# UNITED STATES PATENT AND TRADEMARK OFFICE

APPLICATION NO.	FILING DATE	FIRST NAMED INVENTOR	ATTORNEY DOCKET NO.	CONFIRMATION NO.
10/520,541	01/04/2005	Alain Virgl	15675P566	9359

**Office Action Summary**

## **DETAILED ACTION**

FIG. 3

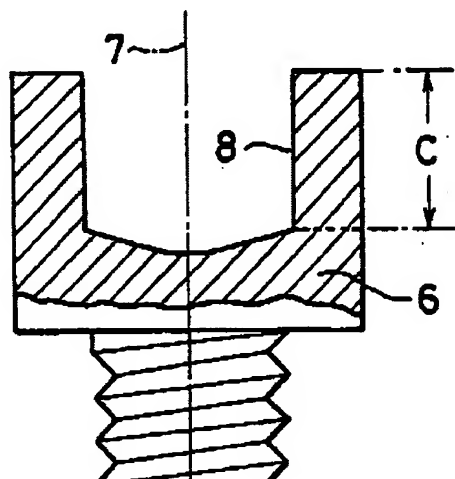
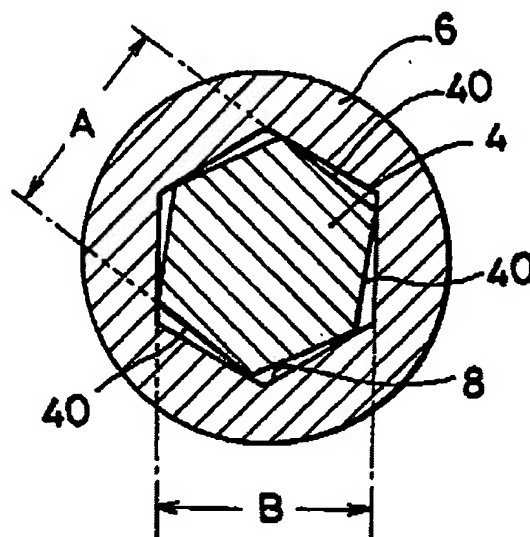
RE claims 1-2: '021 teaches in Figs 3 and 4 a hollow socket head fastener with a depth greater than 0.6 times a diameter of the socket, but is silent on the steel and carbon content of the metal. ASM teaches that "grade 1022 steel is a popular low-carbon steel for threaded fasteners" on page 7 of 17. Examiner takes Official Notice that Grade 1022 steel is defined as having 0.17-0.23% Carbon. Note that this a product claim, and the method of forming the device is not germane to the issue of patentability of the device itself. Therefore, it would have been obvious to one of ordinary skill in the

Re claim 3: '021 specifies that the depth "C" (which examiner notes does not include the depth of the bottom angled recess) is at least 60%.

Re claim 3: A deeper socket of 0.8 or more of the socket diameter would be obvious to one of ordinary skill in the art, if the socket needed to span a deeper hole in a substrate or allow for deeper/longer engagement with the driving tool. Such proportions are within bolt head standards. Further, examiner notes that applicant did not specify a particular diameter, and clearly '021 has a socket diameter that approaches zero, where the angled bottom of the socket tapers to a point.

FIG. 3

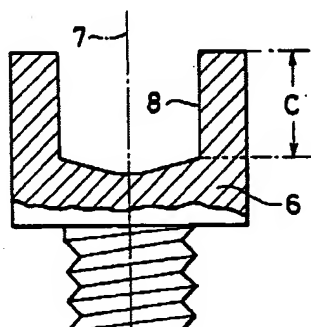
RE claims 1-2: '021 teaches in Figs 3 and 4 a hollow socket head fastener with a

depth greater than 0.6 times a diameter of the socket, but is silent on the steel and carbon content of the metal. Cassidy teaches that a low carbon steel for threaded fasteners" on pages 3-4, per below:.

Re claim 3: '021 specifies that the depth "C" (which examiner notes does not include the depth of the bottom angled recess) is at least 60%.

A deeper socket of 0.8 or more of the socket diameter would be obvious to one of ordinary skill in the art, if the socket needed to span a deeper hole in a substrate or allow for deeper/longer engagement with the driving tool. Such proportions are within bolt head standards. Further, examiner notes that applicant did not specify a particular diameter, and clearly '021 has a socket diameter that approaches zero, where the angled bottom of the socket tapers to a point.

**Fig. 2****Response to Arguments**

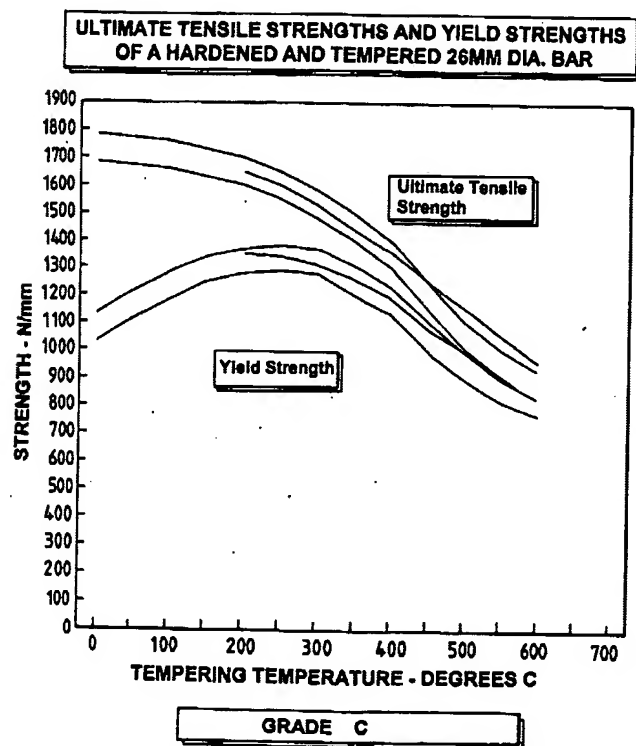
Re claim 11: Minimum tensile and yield strengths as claimed are taught in Fig 2 below, noting Mpa = N/mm Strength of graph.
